**Re: PA22-023- Brodie Rezone PRD – Technical Review 1**

RE: Brodie Subdivision, File# PA22-023  
45 lot subdivision with potential zoning change  
8703 60<sup>th</sup> ST NE & Parcel # 30052500303900; 30052500303800; 30052500302300

SUBJECT: PA22-023 Brodie Rezone PRD  
8703 & 8719 60th St NE, and 6117 83rd Ave NE  
APN's: 30052500303900, 30052500302300, 30052500303800

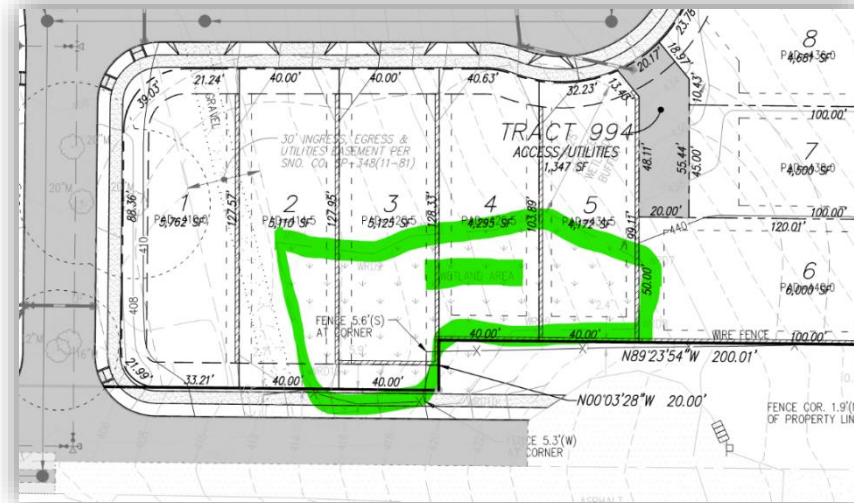
10. Tract 998 proposes to include a portion of the proposed wetland buffer addition. This 644 sq. ft. buffer addition area will need to be relocated outside of the tract and not north of the proposal vault. Suggest moving the vault further north and incorporating the required buffer addition, south of Tract 998. Critical areas and their buffers must be incorporated into separate tracts; revise plans to remove that area from Tract 998 and include this buffer addition into Tract 999.

11. The provided plans appear to include proposed landscaped areas into the active open space area calculation of Tract 998; revise calculations to exclude the proposed Tract 998 buffer landscaping from the dedicated active open space area.
